Design Review Committee

June 19, 2019

DEPARTMENT OF PLANNING AND ZONING PLANNER'S REPORT

PLANNER'S REPORT

SITE PLAN

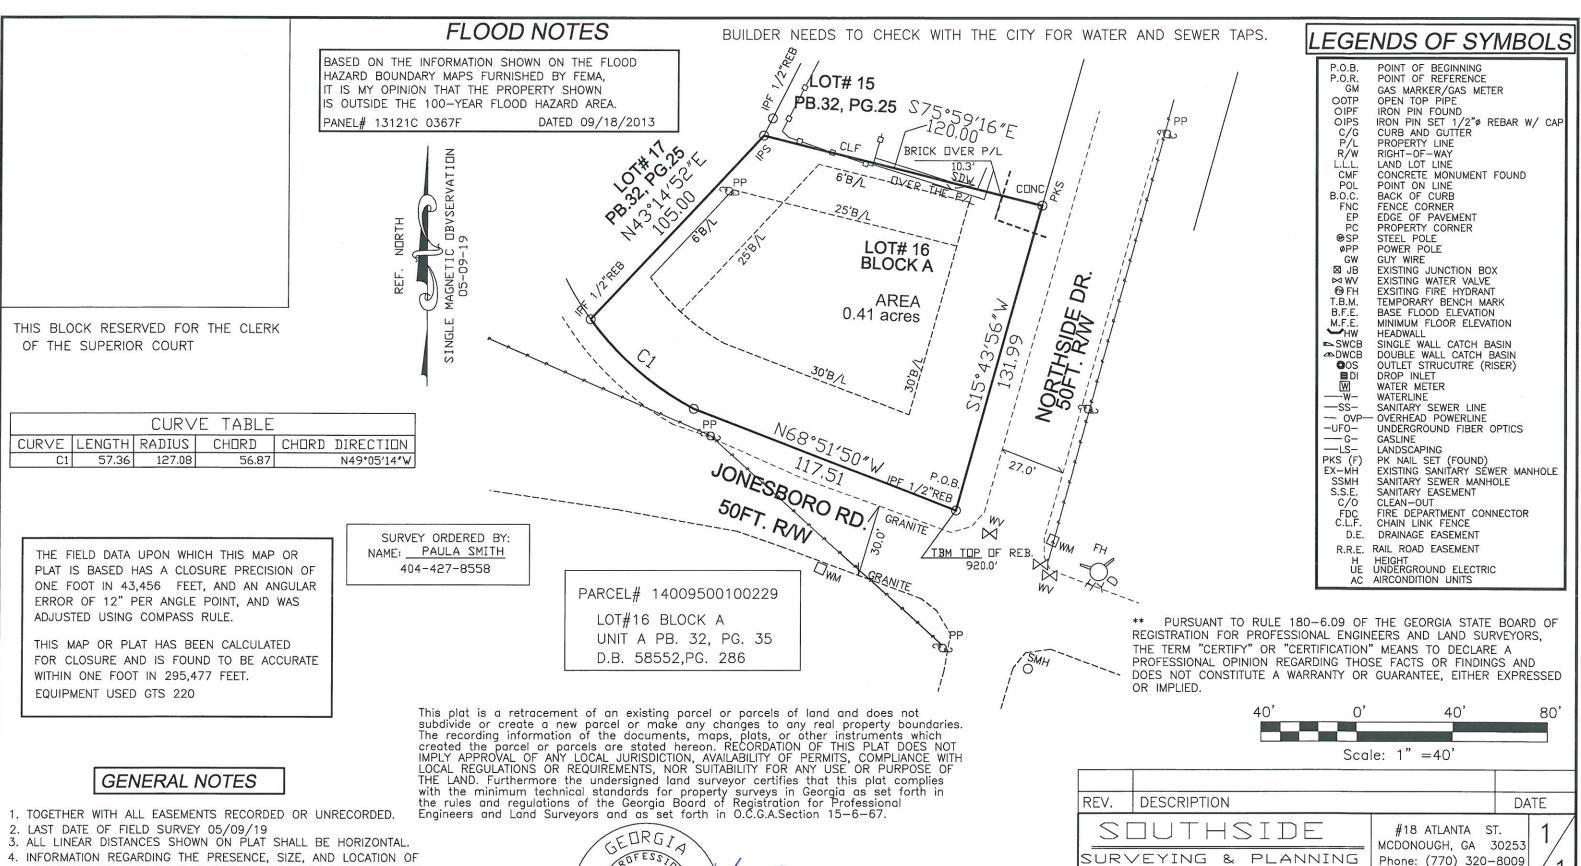
STAFF COMMENT: The plans should include a new sidewalk on each enfronting street, with a minimum 1' landscape zone and 4' clear zone.

A minimum of one tree is required every 50' in the supplemental area. The application should be revised to ensure at least one tree is located every 50' along both Northside Drive and Old Jonesboro Road frontages.

STAFF COMMENT: The driveway is 15' wide at the curb but expands towards the garage, which is not compliant.

SPEC HOME FOR: ORTHSIDE DRIVE PEVILLE, GEORGIA

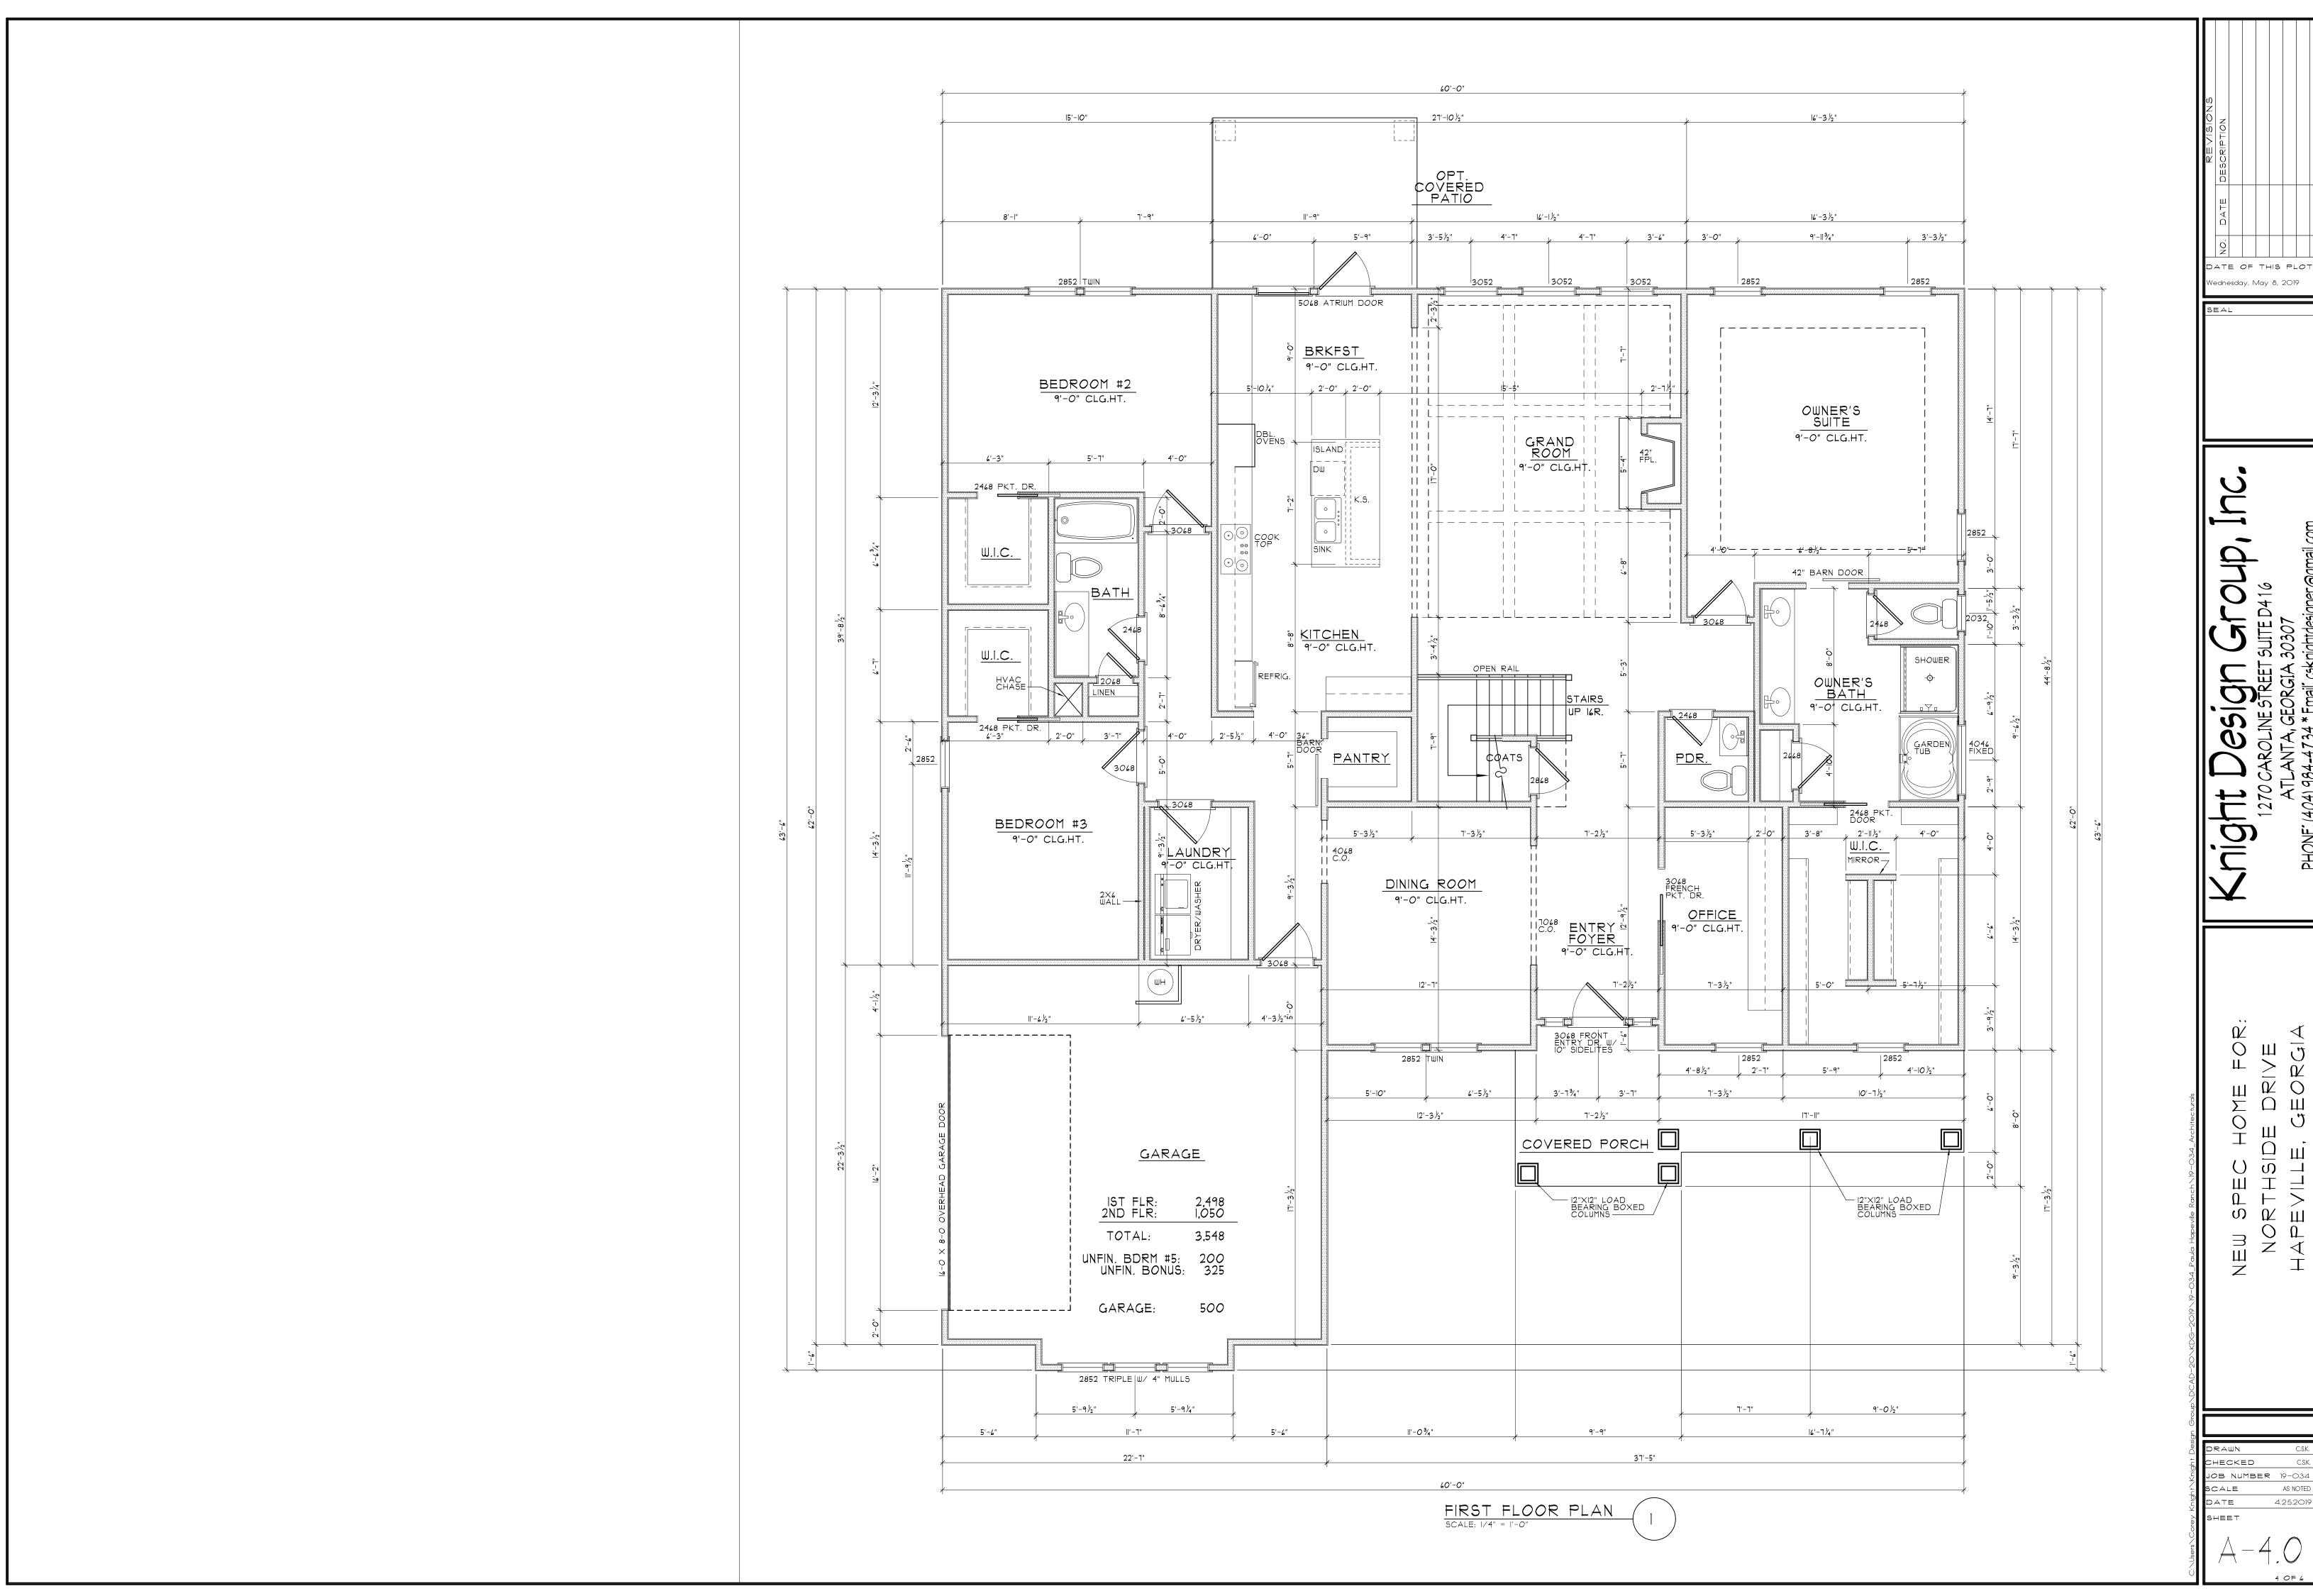
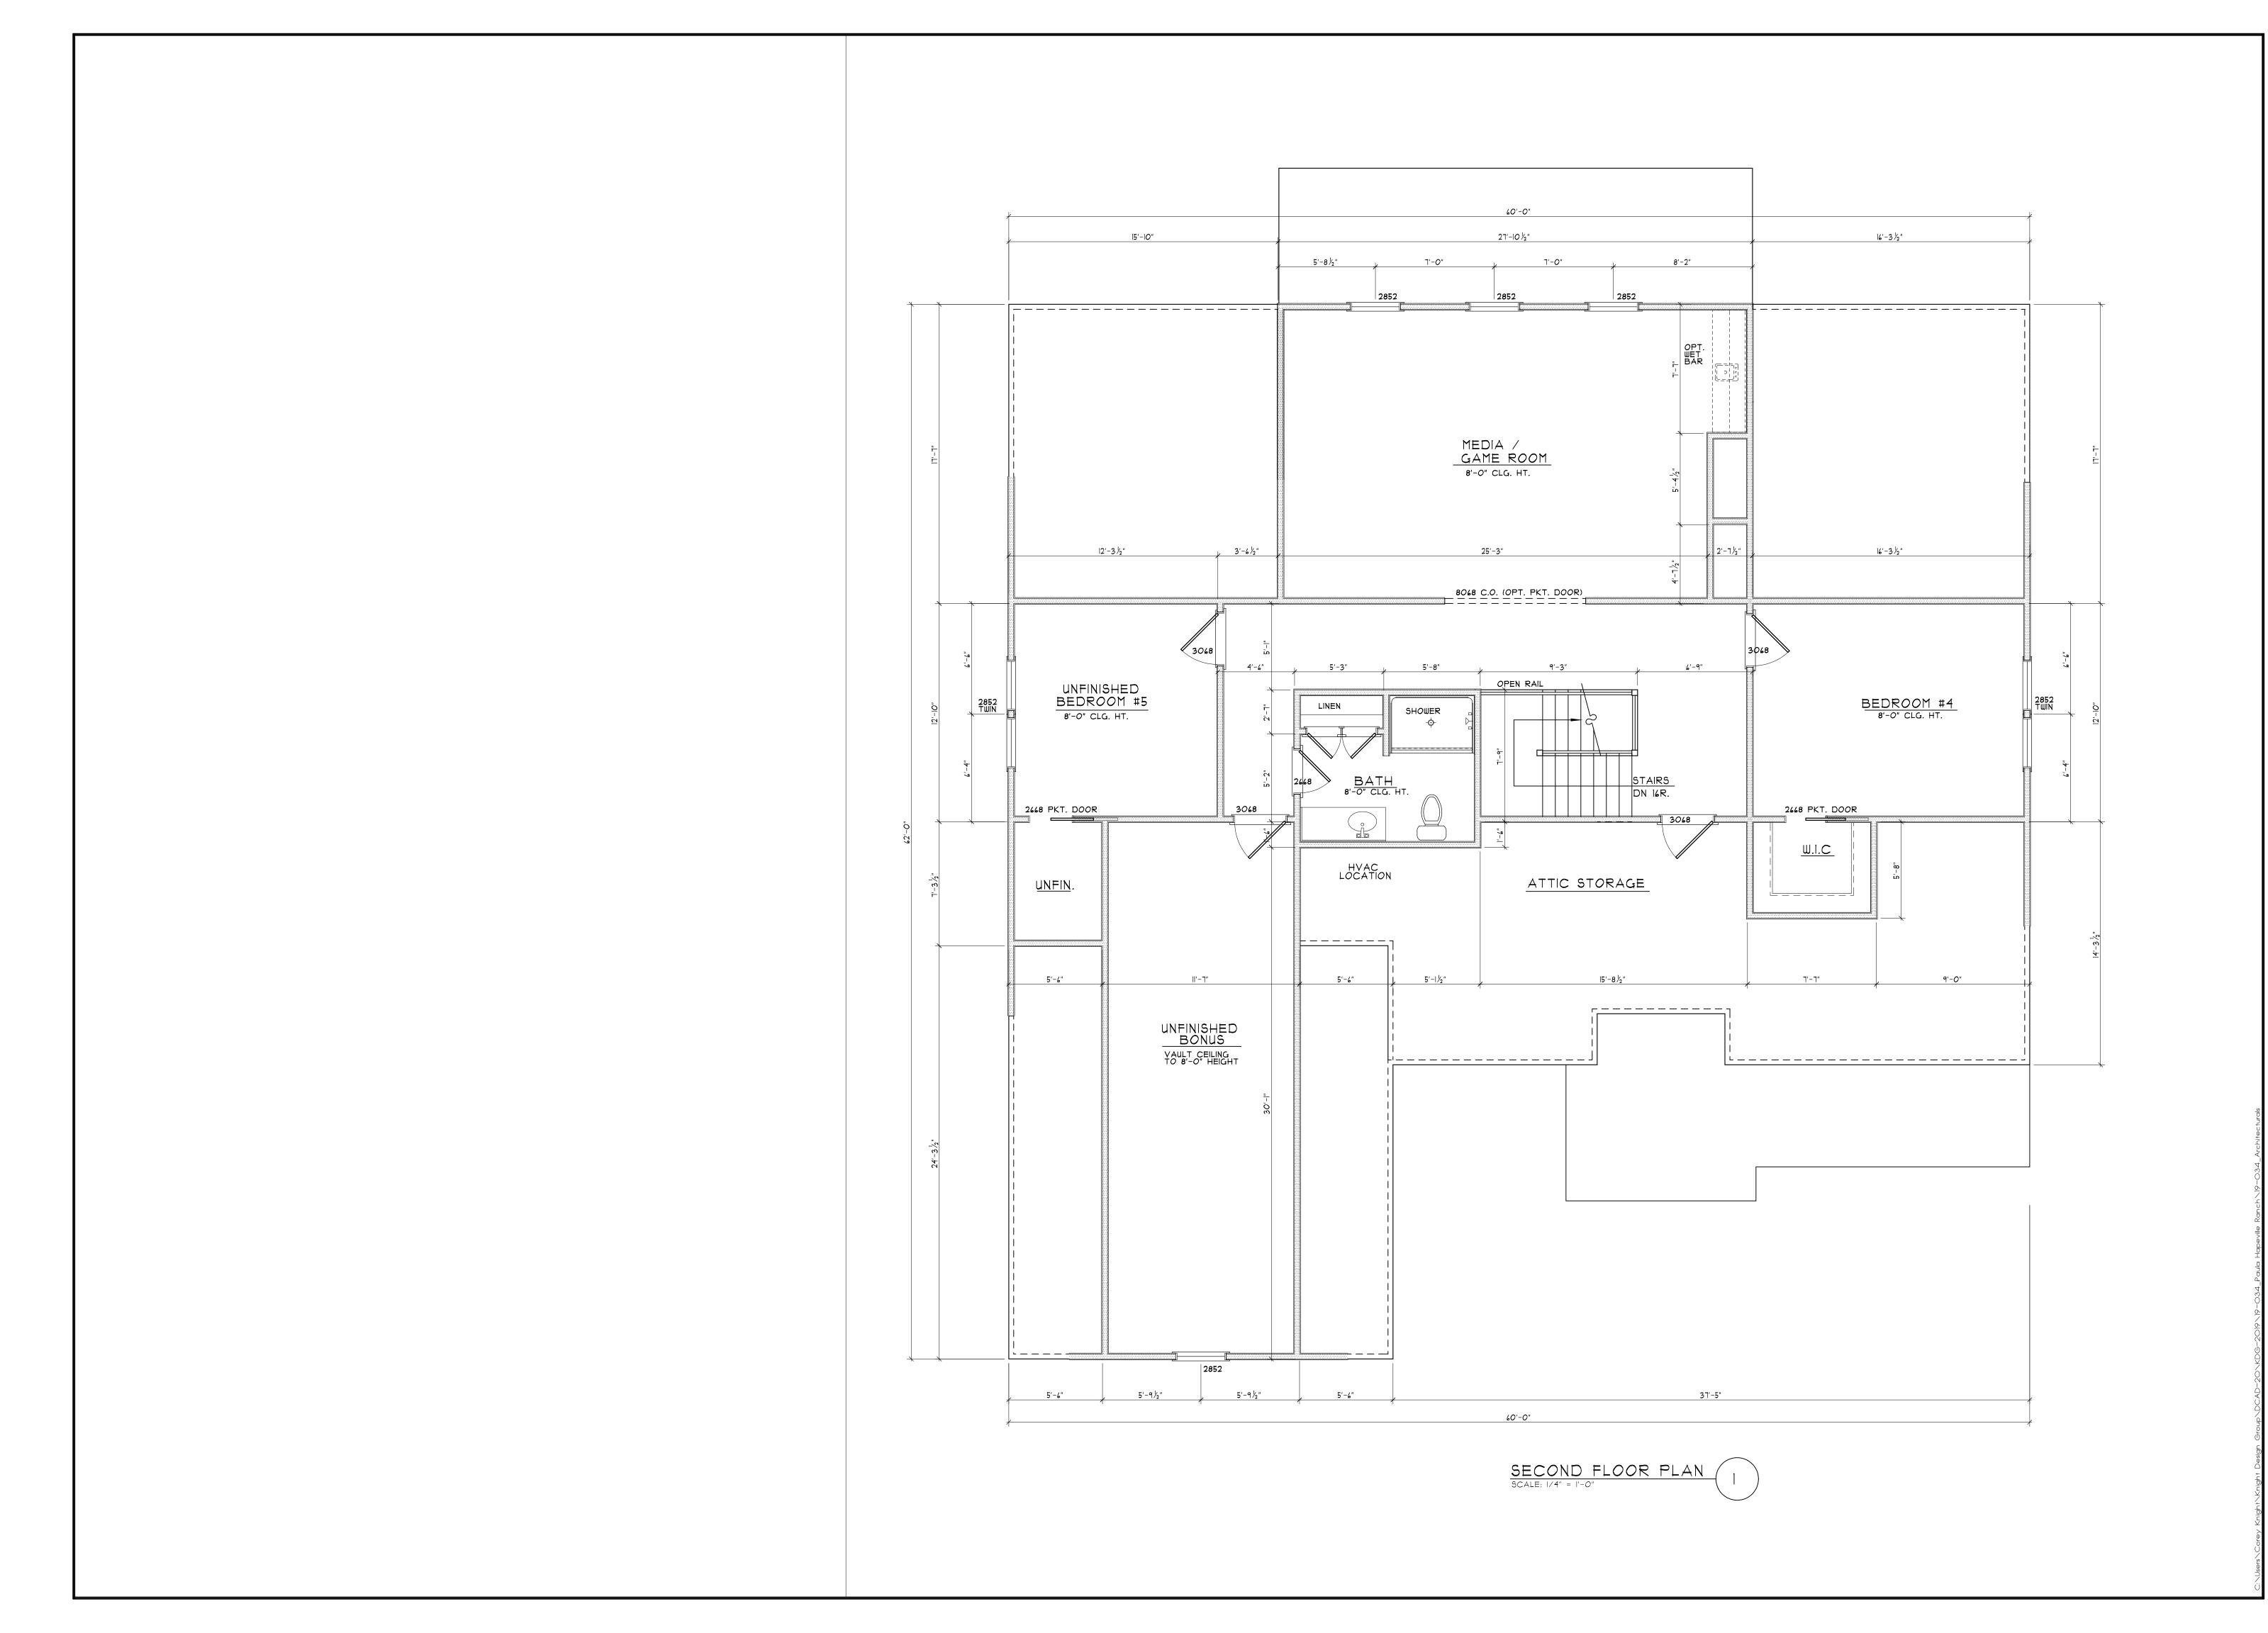
The Applicant should clarify how the mechanical features on the west side of the dwelling will be screened. A light at the front door should be included in plans.

The Applicant should ensure the roof shingles have a warranty of at least 30 years and indicate the warranty on the plans. The Applicant should indicate the material of the gutters and downspouts and show downspouts on the plans.

The Applicant should provide the material used for the porch columns. Porches must be made of painted or stained wood, stone, brick, or ornamental metal.

The Applicant should provide the spacing between porch columns, ensuring they are spaced no more than 8' on center.

Building numbers are required and should be shown on plans.
